Part VIII Planning Report

Sandyford Maintenance Depot

Client: Dun Laoghaire-Rathdown
County Council

Project Name: Sandyford Maintenance Depot
Project Number: 21_046
Report Title: Part VIII Planning Report
Filename: RPT-21_046-002

Location *rawing 21 S 1 2 e . P*

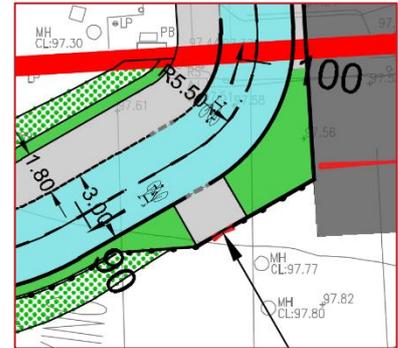
Summar *ropped kerb and tactile paving are not been indicated at the crossing of the proposed cycle track adjacent the new pedestrian access gate at the Sandford Maintenance depot.*

Dropped kerbs and tactile paving have not been indicated at the pedestrian crossing of the proposed cycle track adjacent the new pedestrian access gate to the maintenance depot. The footway and cycle track are indicated at different levels resulting in a kerb greater than 6mm between the two facilities.

Location *rawing 21 S 1 2 e . P*

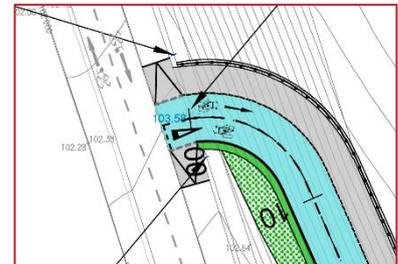
Summar *isk of collision between pedestrian and cyclist at the transition between the proposed two-way cycle track and the existing facilities on the Drummartin Link Road.*

At the transition between the proposed two-way cycle track and existing cycle track and footway on the Drummartin Link Road the existing footway is indicated as being discontinuous across the cycle track with pedestrians required to give way to cyclists. Pedestrians on the footway may not expect to have to give way at this location leading to them being less attentive to approaching cyclists resulting in an increased risk of them entering the cycle track across the path of an oncoming cyclist and pedestrian-cyclist collisions.

The footway should remain continuous at this location with cyclists required to yield to pedestrians before crossing the footway and entering the existing cycle facilities when it is safe to do so. Relocate the yield symbol and line as necessary.

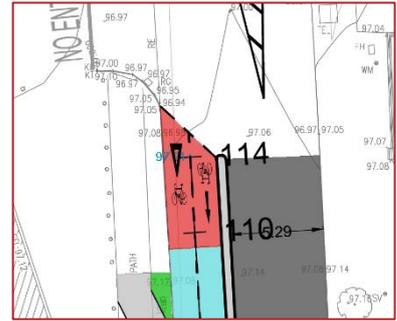
- 4.1 Access/egress to the proposed two-way cycle track has been indicated on Bracken Road adjacent the vehicular entrance to the Maintenance Depot. It is unclear from the drawing provided if a dropped kerb will be provided at this location to permit safe access for cyclists to/from the cycle track. Similarly, the gradient of the transition between the cycle track and Bracken Road carriageway is unclear. Ensure a dropped kerb is provided at this location and that the gradient at the transition can be safely traversed by cyclists.
